**Identification cards — Test methods —**

Part 6:  
**Proximity cards**

AMENDMENT 4: Additional test methods for  
PCD RF interface and PICC alternating field  
exposure

Amendment 4 to ISO/IEC 10373-6:2001 was prepared by Joint Technical Committee ISO/IEC JTC 1, *Information technology*, Subcommittee SC 17, *Cards and personal identification*.

Figure 1 — ESD test circuit

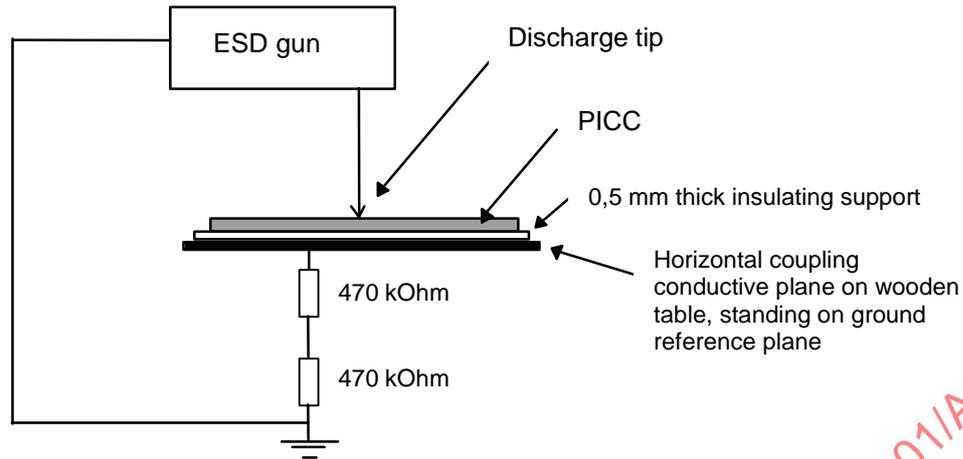
Replace Clause 5 and subclauses 5.1, 5.2 and 5.3 with the following:

The purpose of this test is to check the behaviour of the card IC in relation to electrostatic discharge (ESD) exposure in the test sample. The PICC under test is exposed to a simulated electrostatic discharge (ESD, human body model) and its basic operation checked following the exposure.

Refer to IEC 61000-4-2:1995.

#### a) Main specifications of the ESD generator:

- energy storage capacitance:  $150 \text{ pF} \pm 10 \%$ ;
- discharge resistance:  $330 \Omega \pm 10 \%$ ;
- charging resistance: between  $50 \text{ M}\Omega$  and  $100 \text{ M}\Omega$ ;
- rise time:  $0,7 \text{ ns}$  to  $1 \text{ ns}$ .

#### b) Selected specifications from the optional items:

- type of equipment: table top equipment;
- discharge method: direct application of air discharge to the equipment under test;
- discharge electrodes of the ESD generator: round tip probe of  $8 \text{ mm}$  diameter.

Figure 2 — Test zones on PICC for ESD test

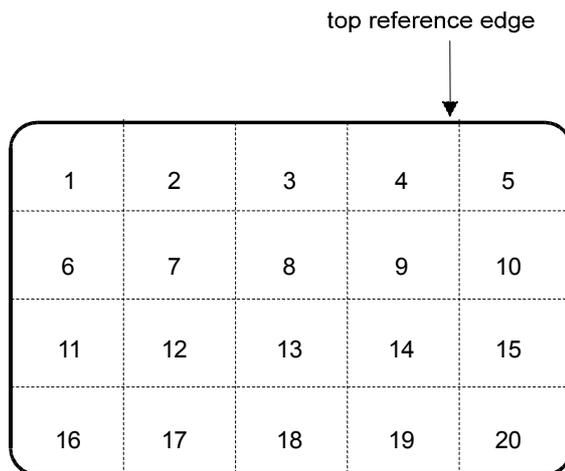
Apply the discharge successively in normal polarity to each of the 20 test zones shown in Figure 2. Then repeat the same procedure with reversed polarity. Allow a cool-down period between successive pulses of at least 10 s.

**WARNING** — If the PICC includes contacts, the contacts should face up and the zone which includes contacts should not be exposed to this discharge.

Check that the PICC operates as intended at the end of the test.
